Comments on the May 2012 Brattle Group Report

I have reviewed the Brattle Group Study and have the following comments:

Figure 2a. MISO Coal Capacity

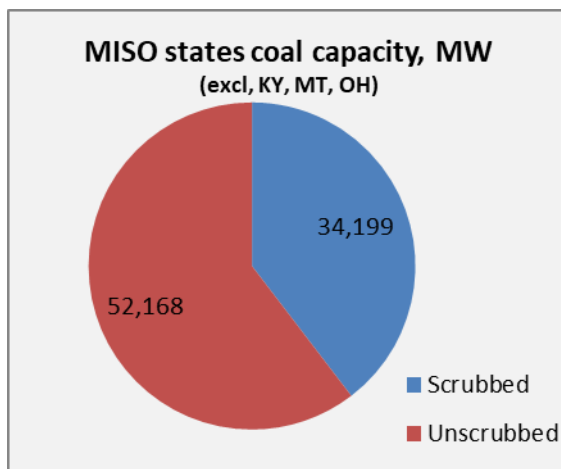
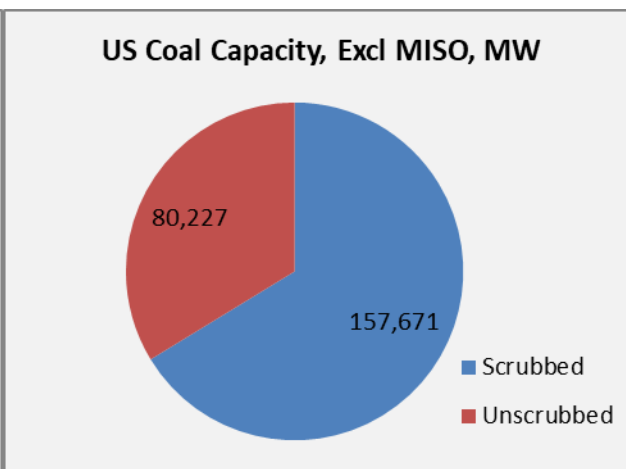
Figures 2a and 2b compare the scrubbed capacity in the in the MISO region versus the rest of the country. Outside of MISO, nearly 66% of coal capacity is scrubbed while only 40% is scrubbed in the MISO region. This has implications for establishing the MISO “soft cap” because Brattle Group looks at historical retrofits in determining their “soft cap”. I would argue that the “soft cap” they have assumed should be raised by about 65% to make it comparable to the rest of the country.

Figure 3. Construction Boilermaker Membership.

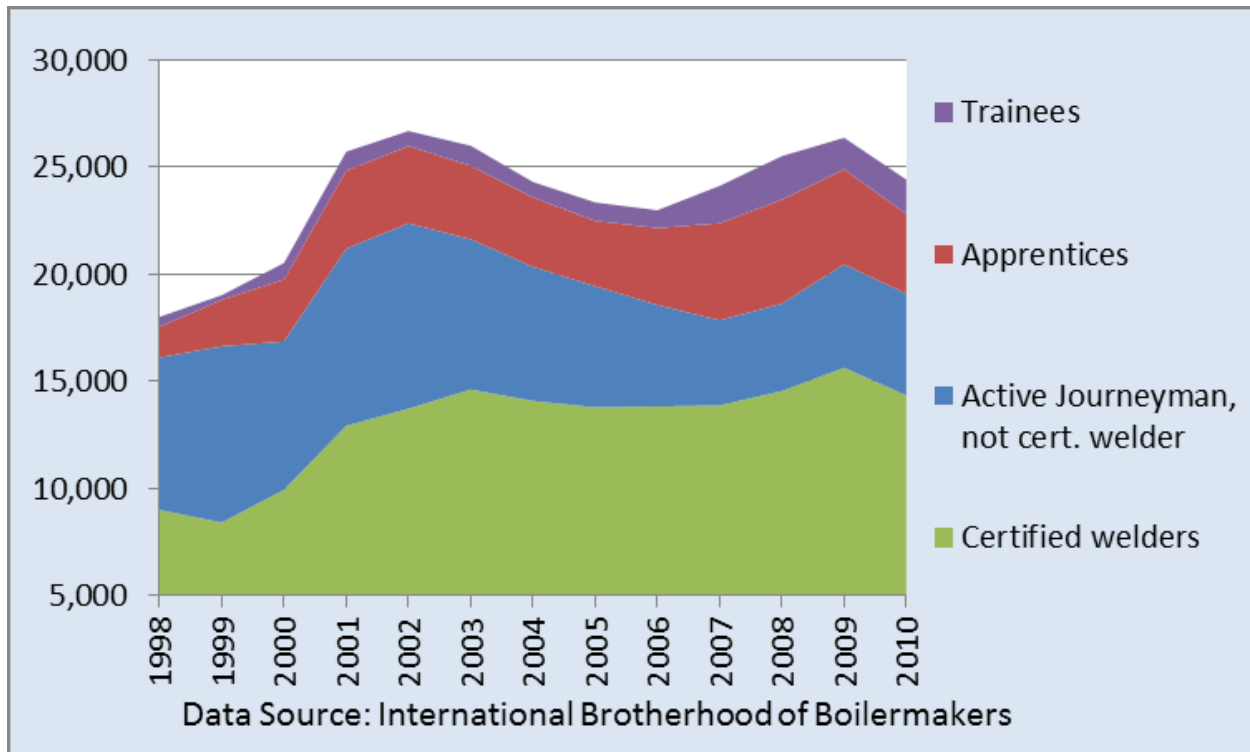
Better data on construction boilermaker employment is available from the National Association of Construction Boilermaker Employers (NACBE) and information on available union boilermakers⁴ is available from the International Brotherhood of Boilermakers. I provided detailed boilermaker statistics in the recent update of the 2002 report.⁵ Figure 3 shows a graph taken out of that report showing the construction boilermaker membership – all of whom are available for utility construction work. In contrast, Brattle Group assumes only 1850 boilermakers available for utility construction out of the BLS estimate of 18,850 total boilermakers (what are all the other guys doing?)

Figure 4. Boilermaker manhours and new scrubber and SCR's in service on coal units

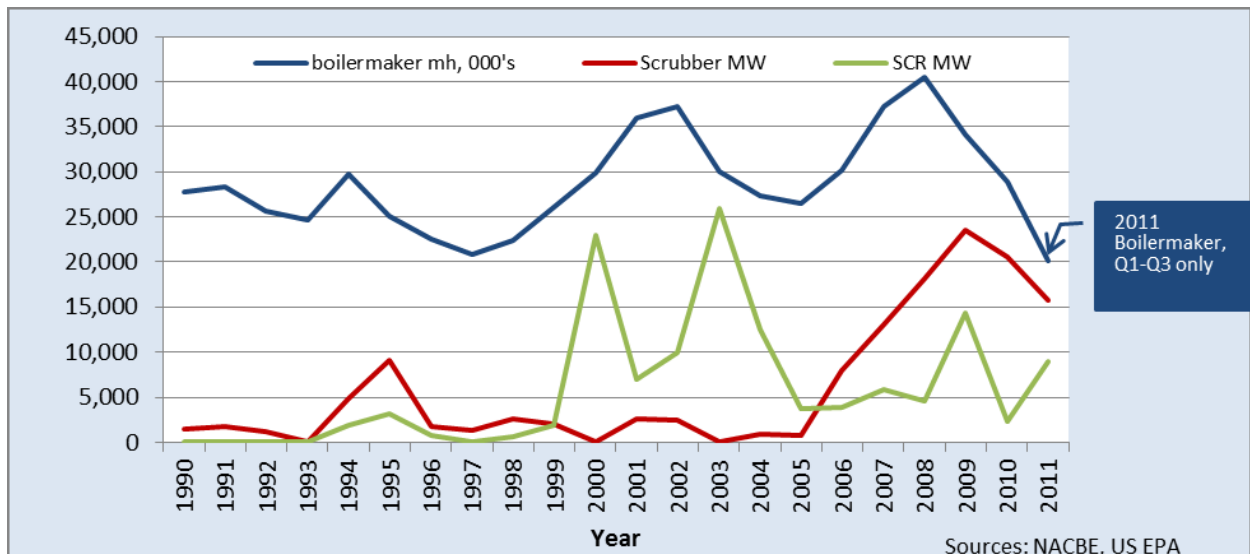
Figure 4 shows boilermaker employment manhours from the NACBE plotted against SCR and scrubber retrofits, and you can see the high correlation between the two. I have a lot more confidence in this data than what BLS generates for the reasons I've described.
